STAFF RECOMMENDATION 748 Roycroft Avenue August 15, 2018

Application: New Construction—Addition
District: Woodland in Waverly Historic Preservation Zoning Overlay
Council District: 17
Map and Parcel Number: 10510020800
Applicant: Cheyenne Smith
Project Lead: Melissa Baldock, melissa.baldock@yahoo.com

Description of Project: Application is to construct a rear addition. The addition contains an attached garage at the basement level.

SITE PLAN

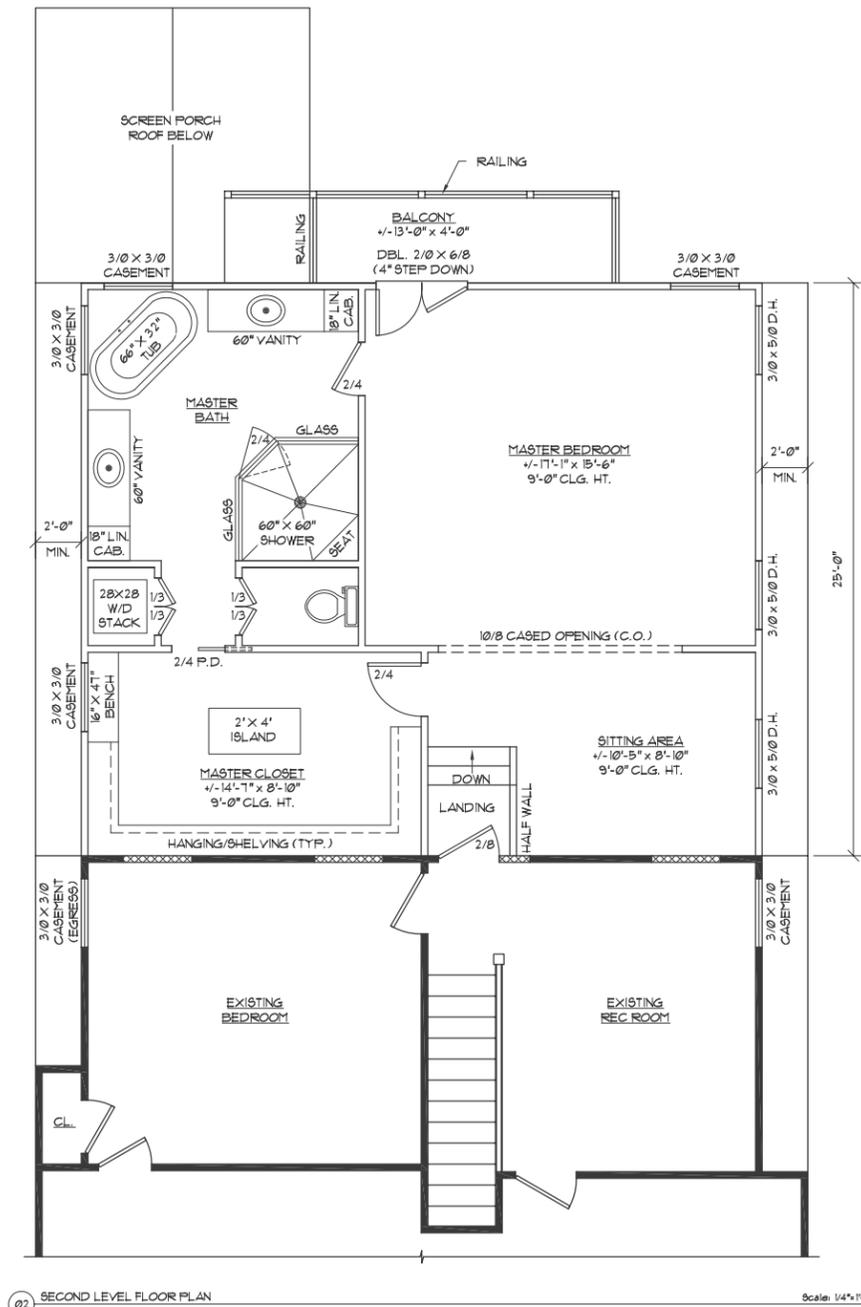
Setback & Rhythm of Spacing: The proposed addition meets all base zoning setbacks. It will be ten feet (10') from the left side property line and approximately six feet (6') from the right side property line. It will be approximately sixty feet (60') from the rear property line. Since the addition is no wider than the historic house, it will not affect the rhythm of spacing along the street. Staff finds that the proposed addition meets Sections III.B.1. and III.B.2.c. of the design guidelines.

SECOND LEVEL FLOOR
PLAN & REAR ELEVATION

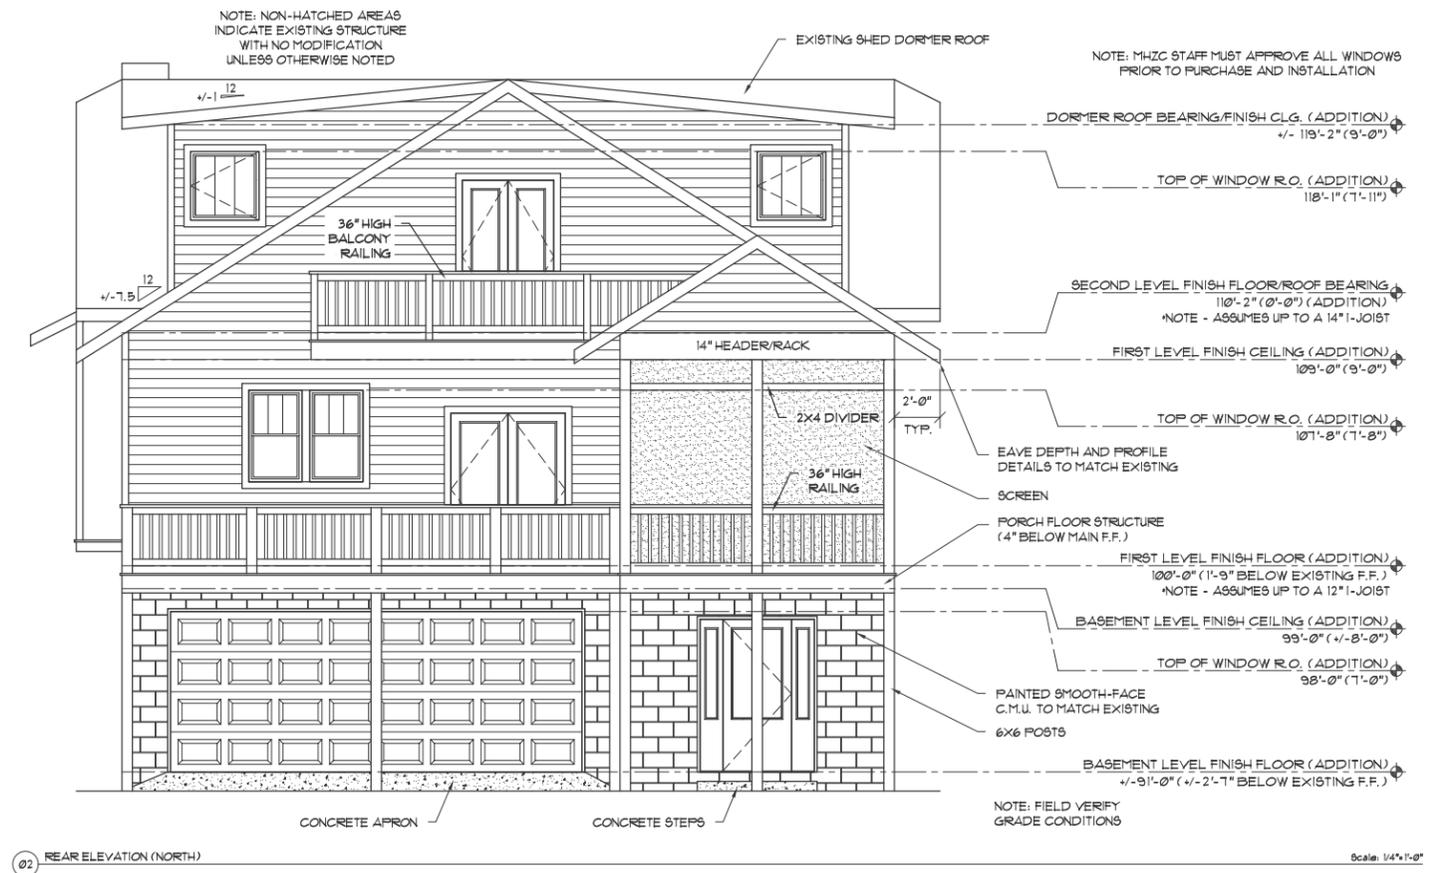
Roof form: The addition's primary roof form is a 7.5/12 gable. The dormers are low-sloped shed dormers. They are inset from the sidewalls two feet (2'), as is typically required. The rear porch also has a gable with a 7.5/12 slope. Staff finds that the proposed roof forms are compatible with the historic house and the historic neighborhood. Staff finds that the roof forms meet Sections III.B.1. and III.B.2.e. of the design guidelines.

EXTERIOR SIDE
ELEVATIONS

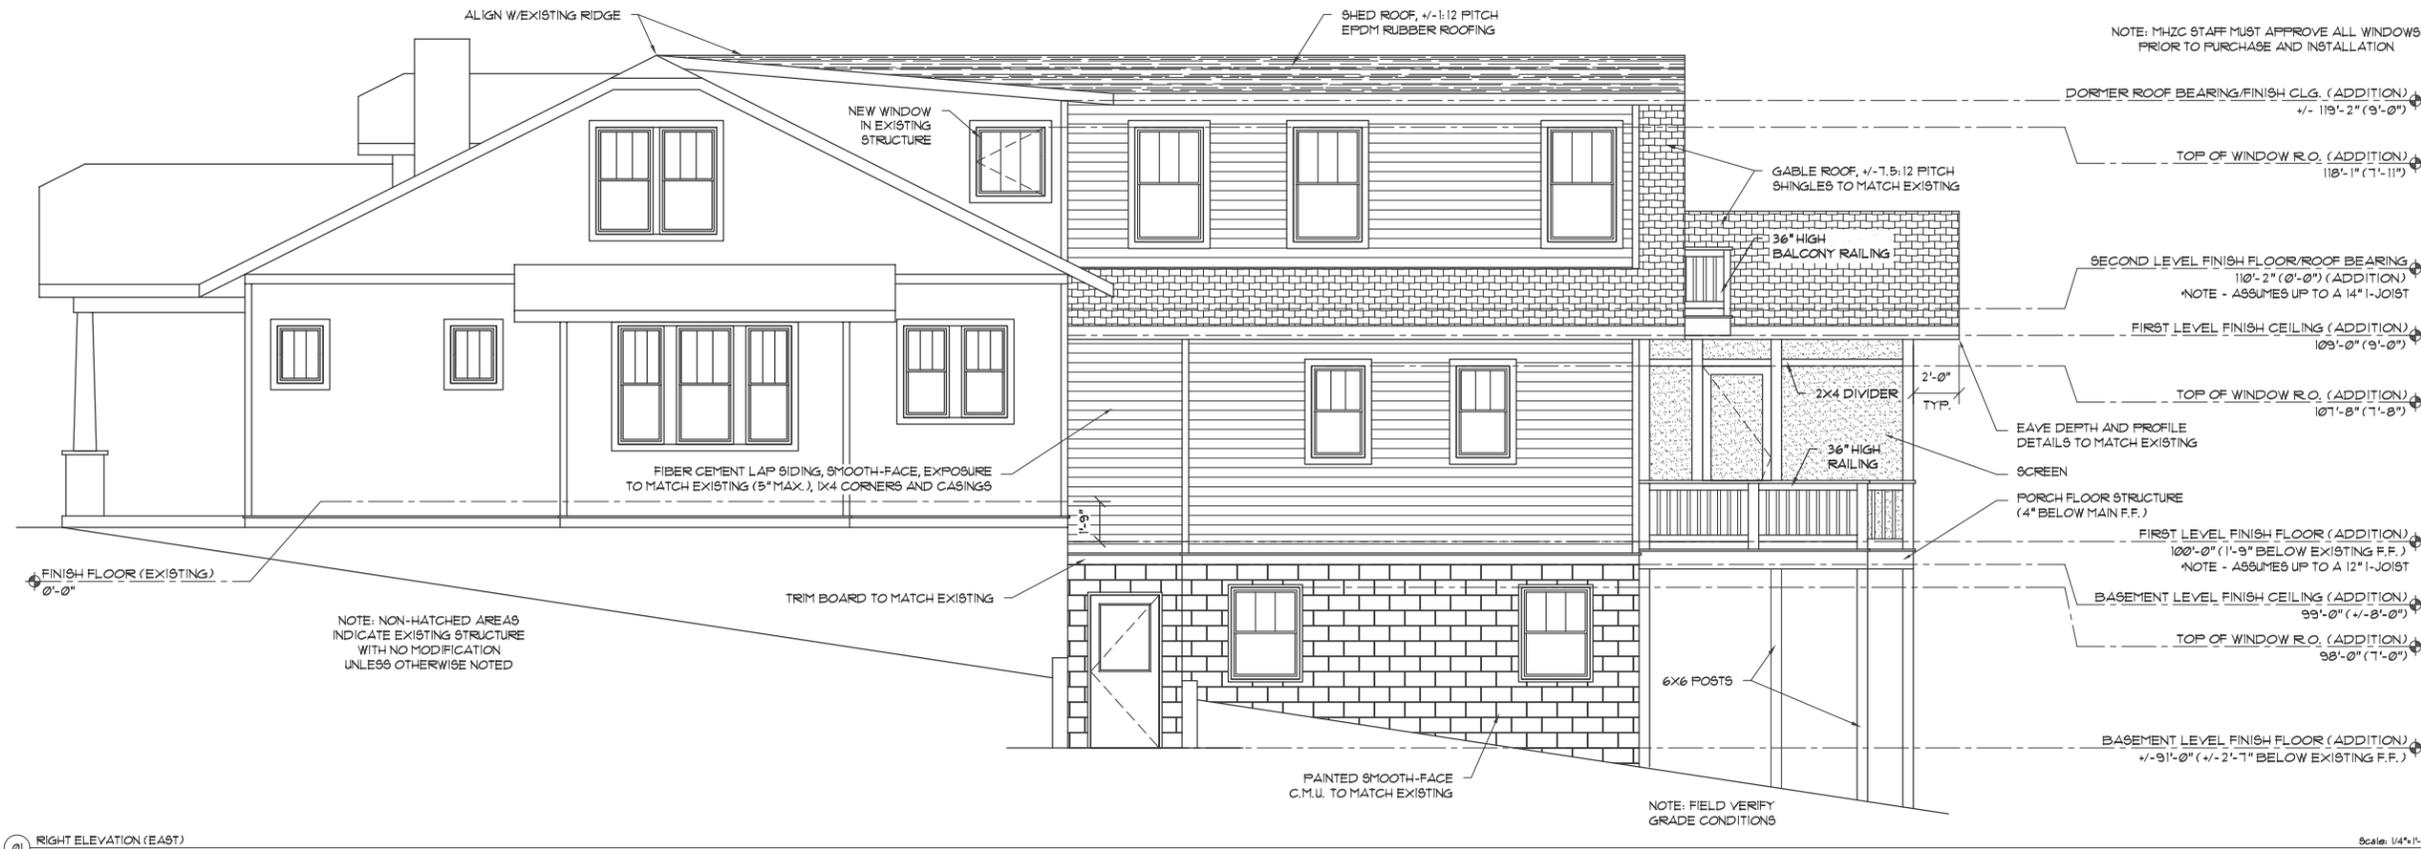
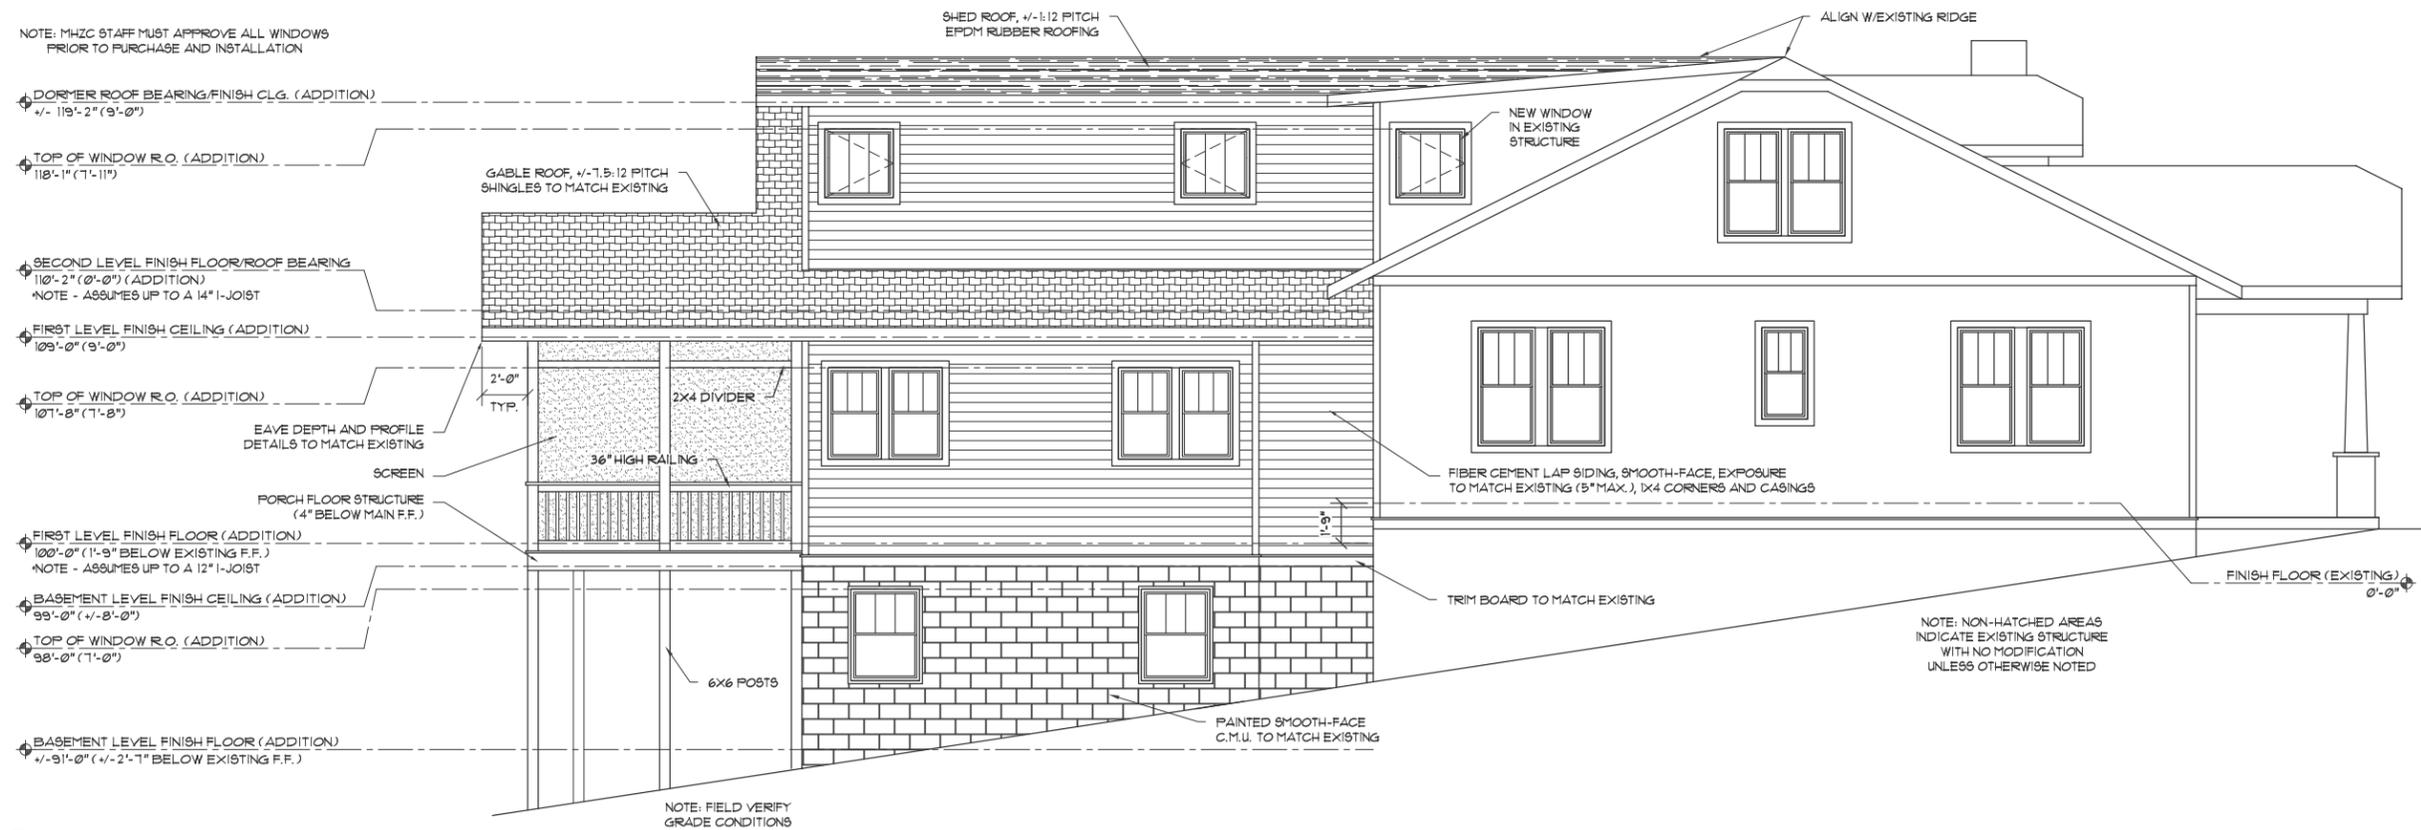
Height & Scale: The proposed addition is no taller and no wider than the existing house. At the basement and first floor, the addition is inset two feet, six inches (2'6") for a depth of five feet (5'). After the inset, the addition steps back out on the ground floor to line up with the side walls of the existing house. On the second floor, the addition ties into an existing rear dormer and will be inset two feet (2'), like the existing dormer. The ridge height will match that of the house, while the eave and foundation heights will be one foot, nine inches (1'9") lower than those on the historic house. Staff finds this to be appropriate as the site slopes steeply down towards the rear. The addition will add thirty-seven feet (37') of depth and approximately one thousand, one hundred, and eighty square feet (1,180 sq. ft.) of footprint, including the rear screen porch and deck, to the existing house.

Proportion and Rhythm of Openings: No changes to the window and door openings on the existing house were indicated on the plans. The windows on the proposed addition are all generally twice as tall as they are wide, thereby meeting the historic proportions of openings. There are no large expanses of wall space without a window or door opening. All paired window openings have a four to six inch (4”-6”) mullion in between them. Staff therefore finds that the addition’s proportion and rhythm of openings meet Sections III.B.1. and III.B.2.g. of the design guidelines.
